ACAS II Bulletin Version 7.1 is coming...

This issue focuses on a forthcoming change to TCAS II – the introduction of the new version 7.1. A regulatory decision regarding implementation was published in the Official Journal of the European Union on 20 December 2011: all existing TCAS II version 7.0 installations must be upgraded before 1 December 2015 and new aircraft must be equipped with version 7.1 from 1 March 2012 to operate in European airspace.

Figure 3: Comparison of “Adjust vertical speed, adjust” and “Level off, level off” RAs

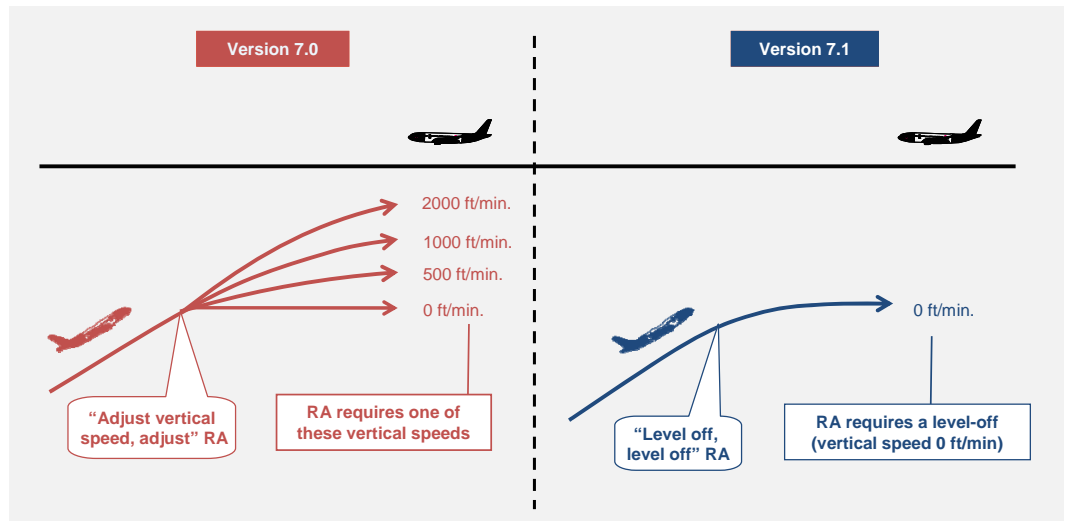
Currently, “Adjust vertical speed, adjust” RAs require a reduction of the vertical rate to 2000, 1000, 500 or 0 ft/min. The new “Level off, level off” RA always requires a reduction of vertical rate to 0 ft/min. The level off is to be achieved promptly, not at the next standard flight level (e.g. FL200, FL 210, etc.).

The “Level off, level off” RA may be issued as an initial RA (as illustrated in Figure 3) or as a weakening RA (following, for instance, a “Climb, climb” or “Descend, descend” RA – see Figure 4) when the vertical distance between the aircraft increases after the initial RA has been issued.

Figure 4: Comparison of weakening “Adjust vertical speed, adjust” and “Level off, level off” RAs

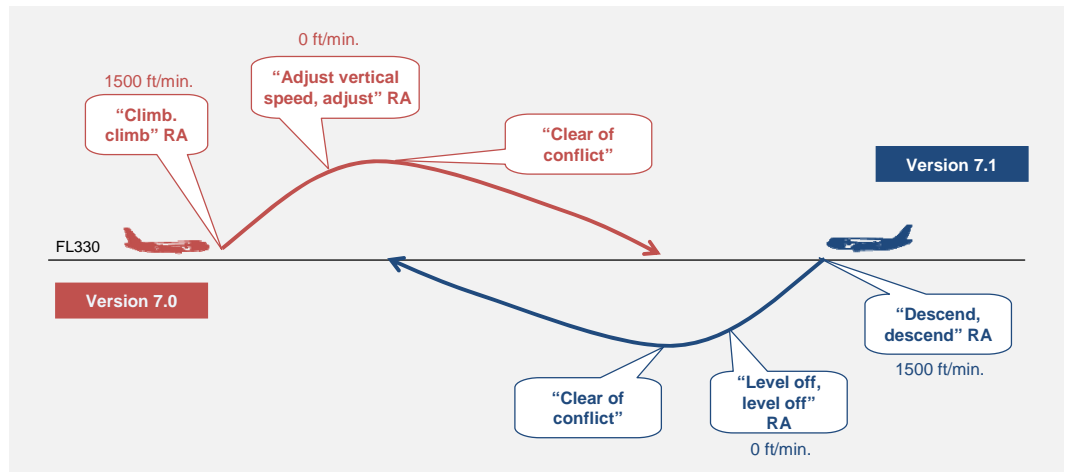
A weakening “Adjust vertical speed, adjust” RA in the existing version 7.0 also always requires a reduction of vertical speed to 0 ft/min. (i.e. level off), so there is no change in pilot actions in these cases.

Figure 5: How the “Level off, level off” RA will reduce instances of level bust

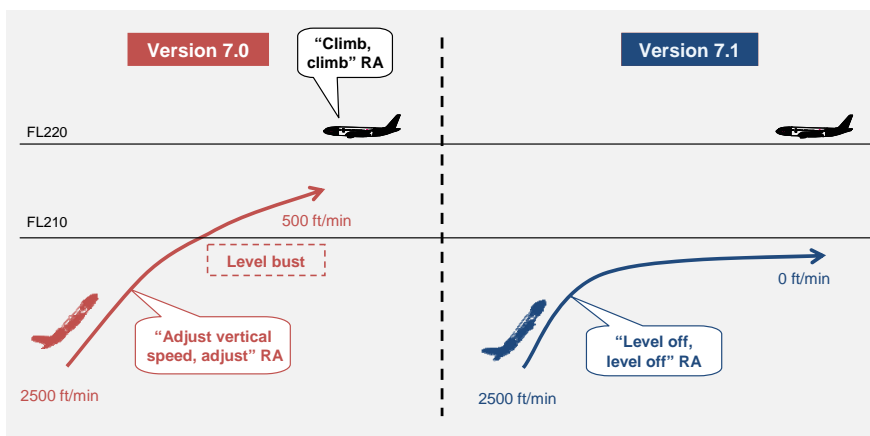
Additionally, replacing the multiple climb/descent rates of the “Adjust vertical speed, adjust” RA, the “Level off, level off” RA will minimise the altitude deviations induced by TCAS (level busts while “flying the green arc”), thus reducing the impact on ATC operations.

It will contribute to the overall reduction of RA occurrences because follow up RAs resulting from the “green arc level bust” should not occur any more (see Figure 5).

Figure 9: TCAS II version 7.1 improved reversal logic

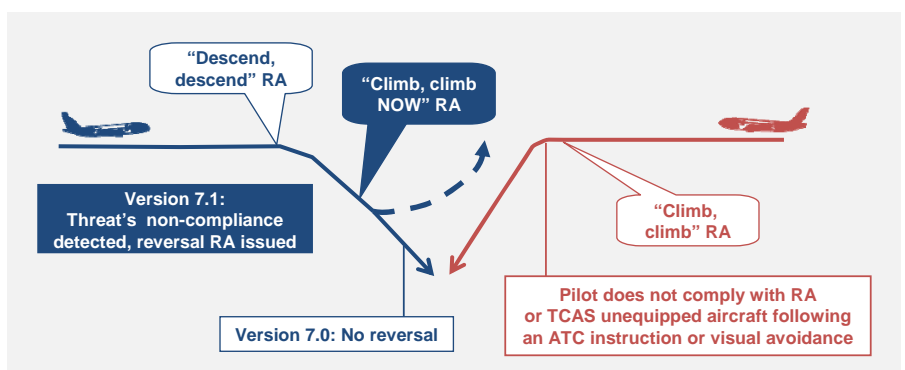
Version 7.1 will bring improvements to the reversal logic by detecting situations in which, despite the RA, the aircraft continue to converge vertically.

A feature has been added to the TCAS logic which monitors RA compliance in coordinated encounters (i.e. when both aircraft are TCAS II equipped). When version 7.1 detects that an aircraft is not responding correctly to an RA, it will issue a reversal RA to the aircraft which manoeuvres in accordance with the RA. In single equipage encounters (i.e. when only one aircraft is TCAS II equipped), version 7.1 will recognise the situation and will issue a reversal if the
